Bid Addendum Two

Project: **Tulip New Utilities Building**
Project No. Tulalip Tribes Project No. 2021-003

Date of Issuance: April 18, 2024

1 NORTH WALL
A4.01 Scale: 1/2" = 1'-0"

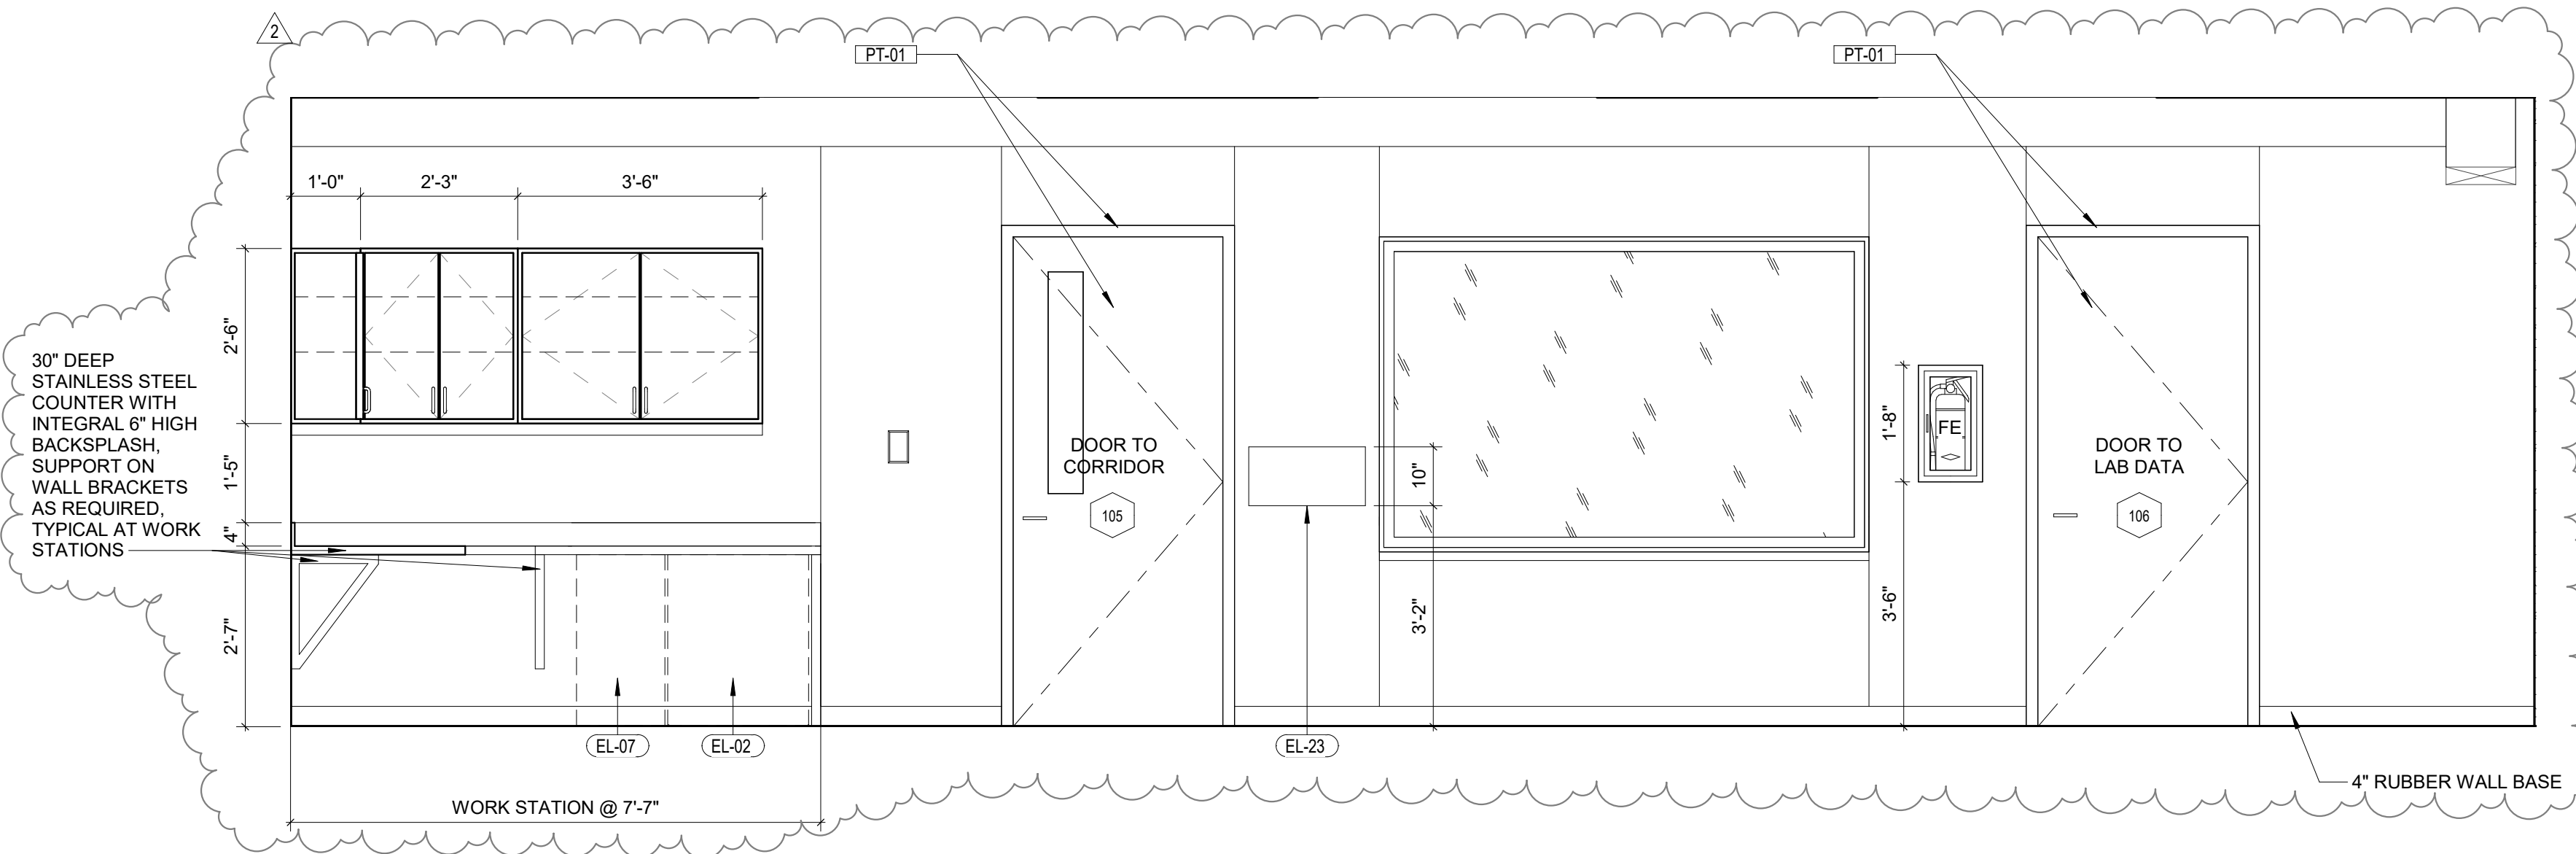
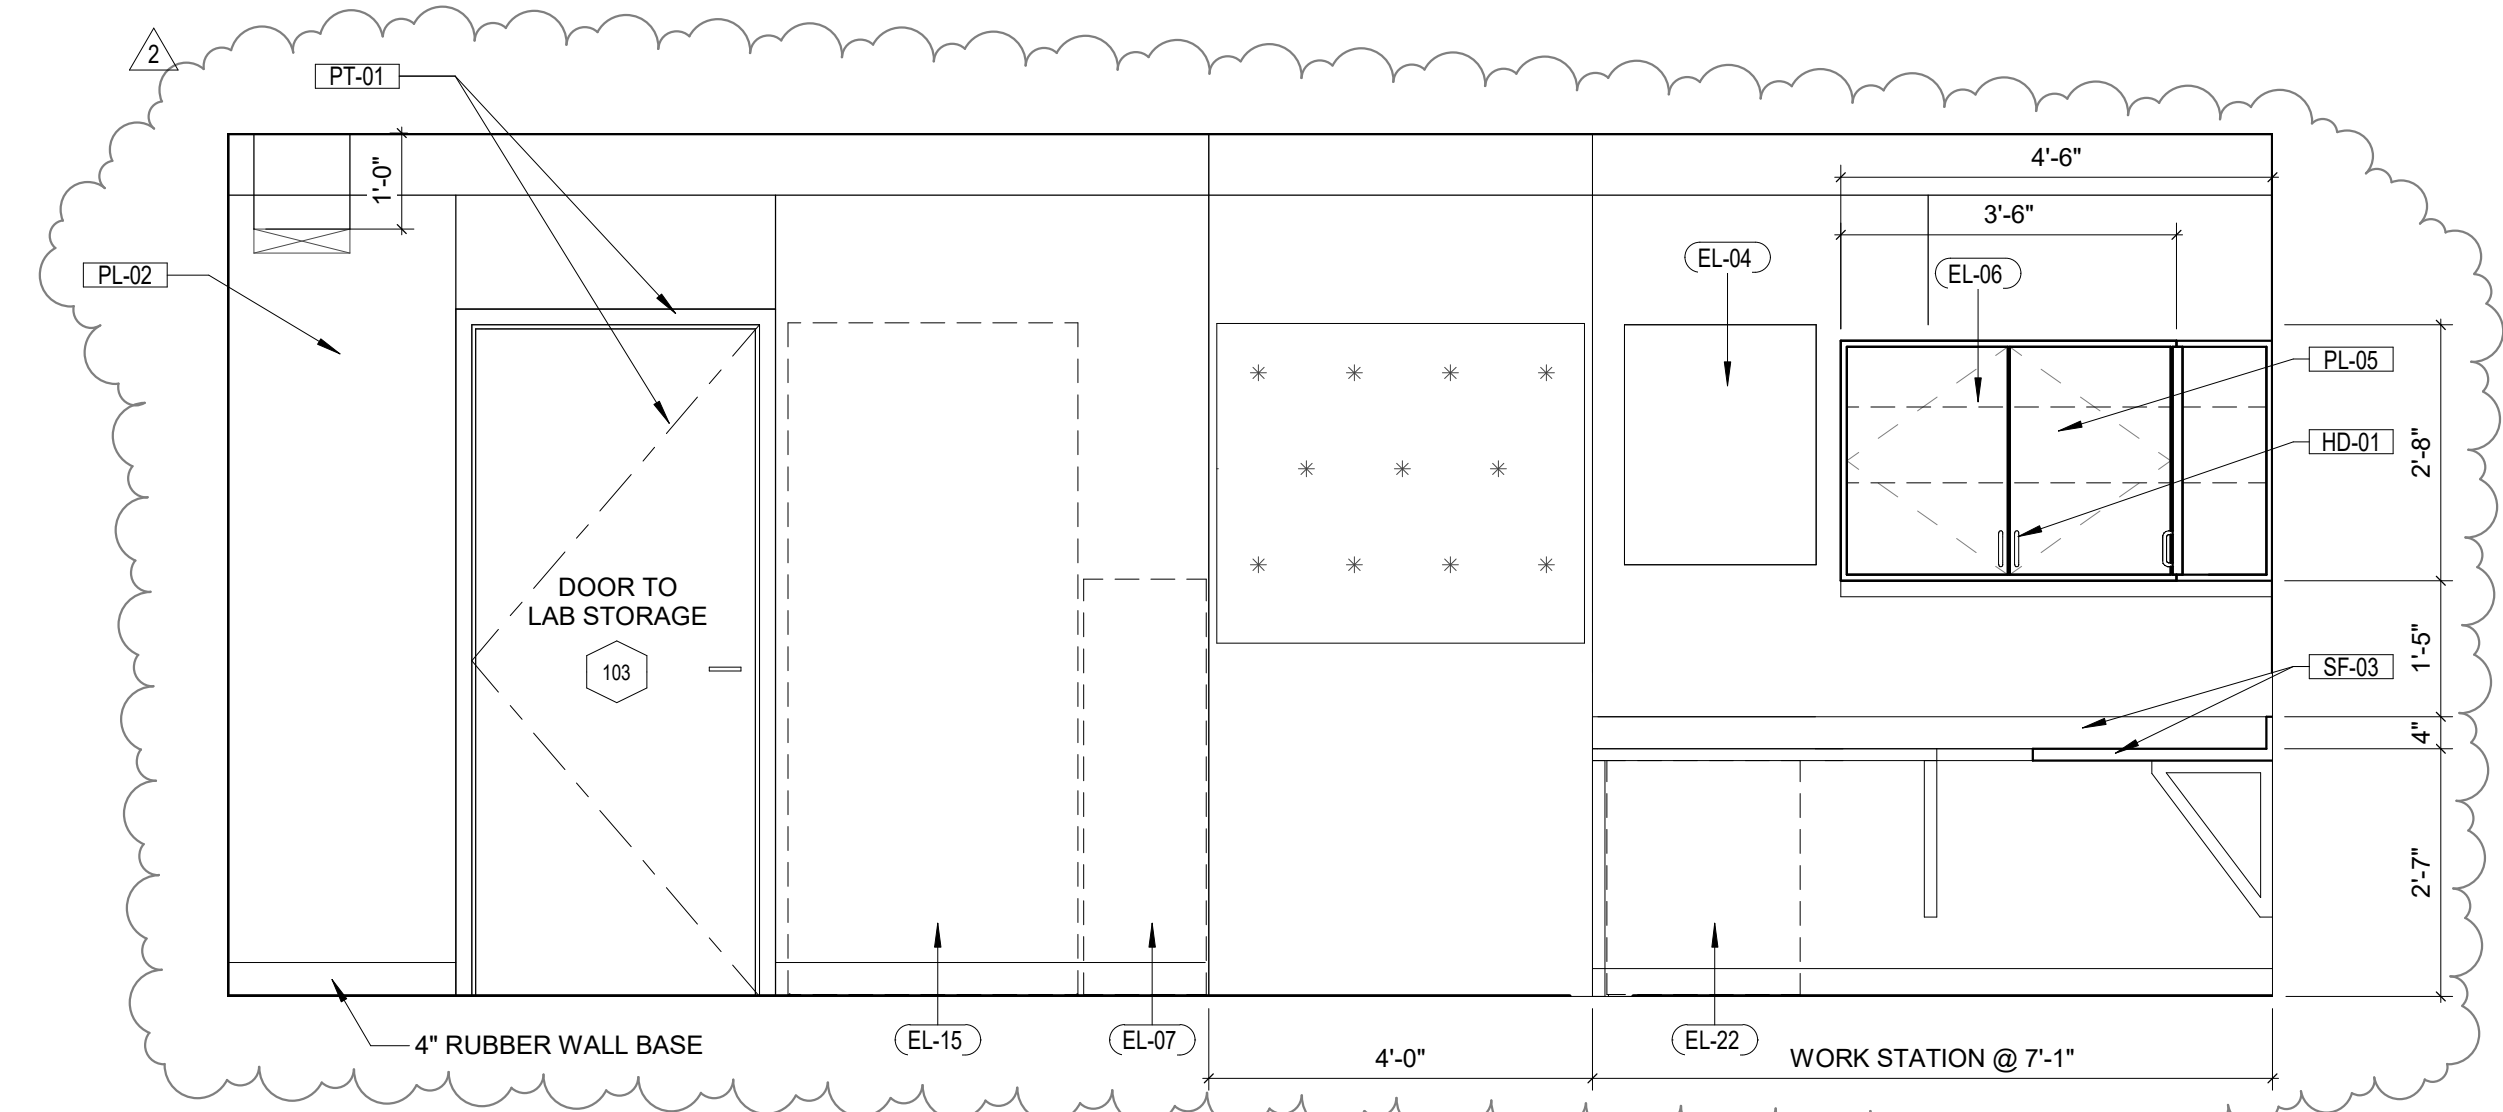
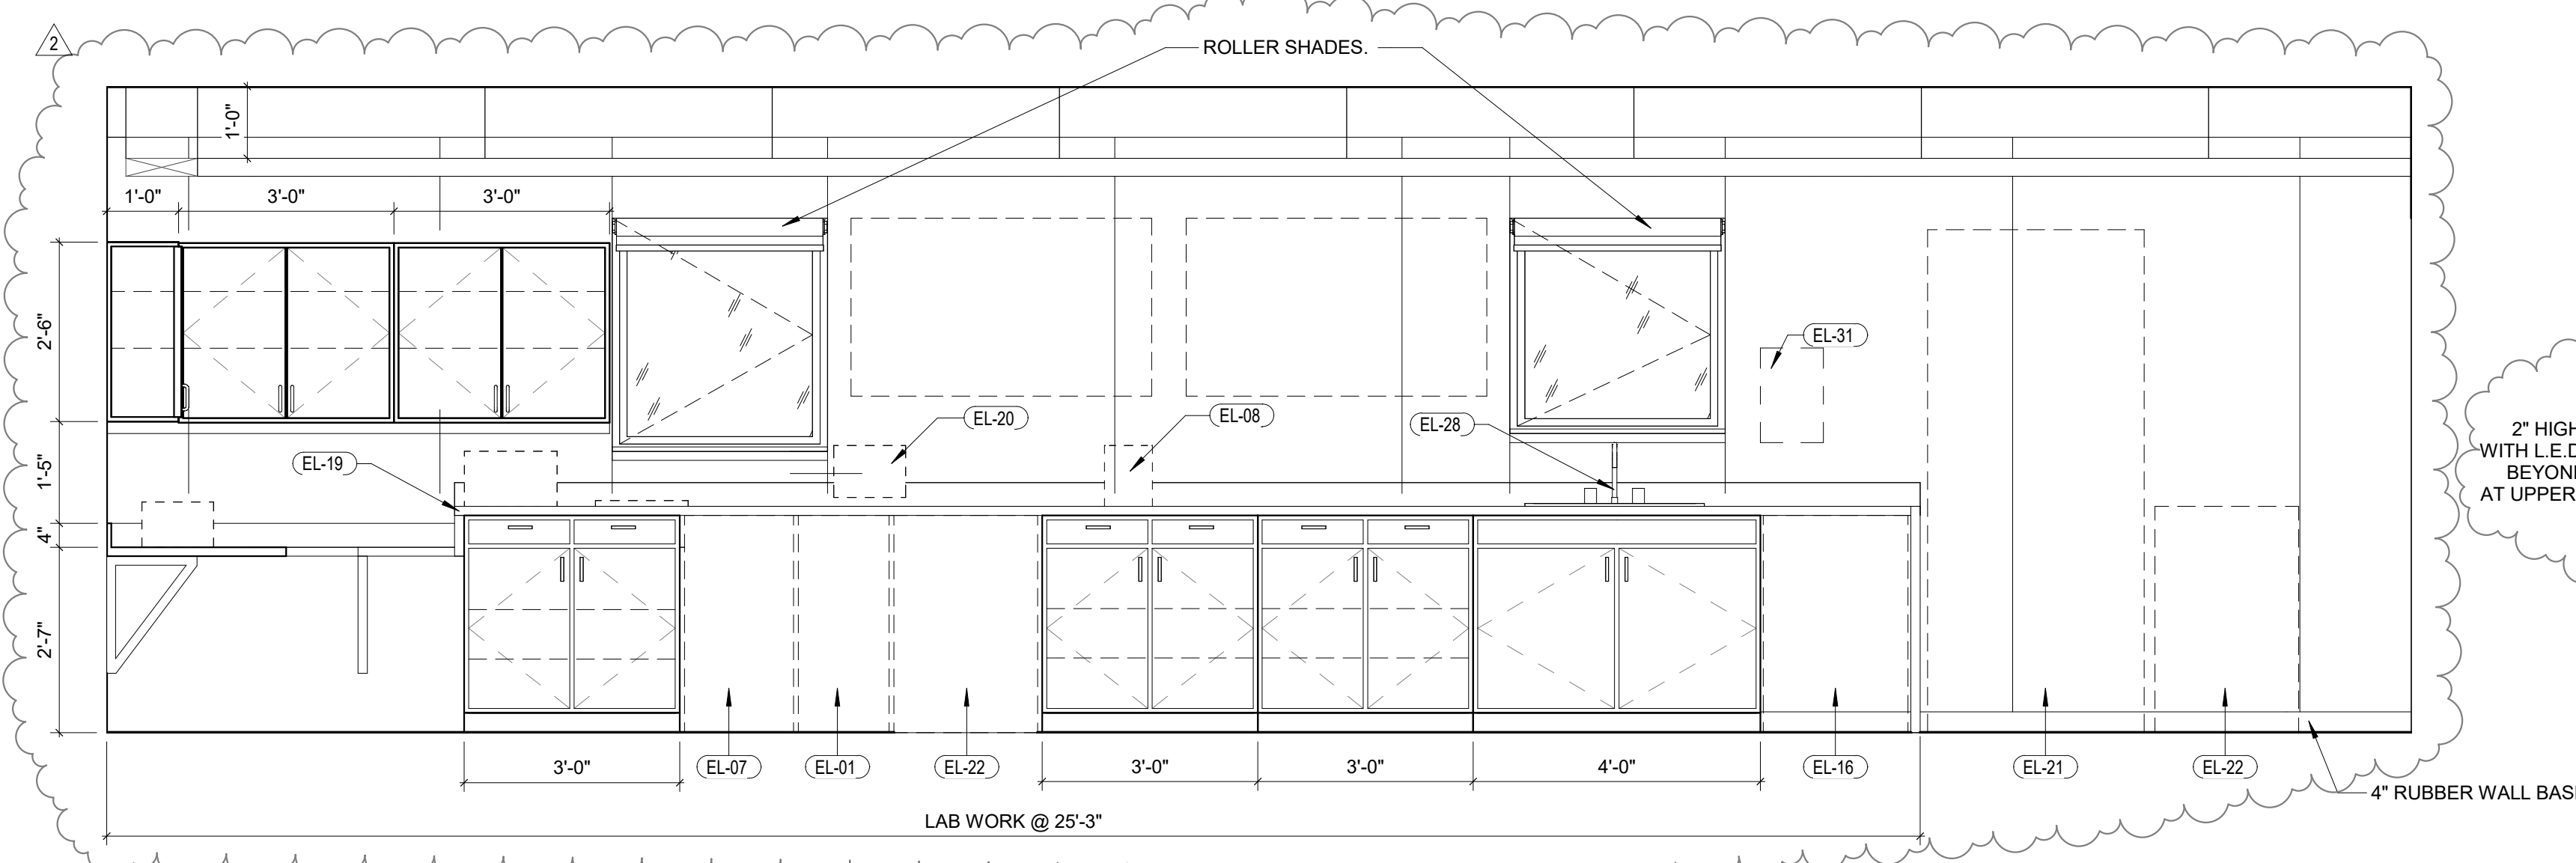
- A3.07 – revisions to lab casework (rev to 30" counter depth), Equipment Schedule (addition of towel dispenser) and dtl bugs
 - A4.01 Changes to lab casework and keynotes
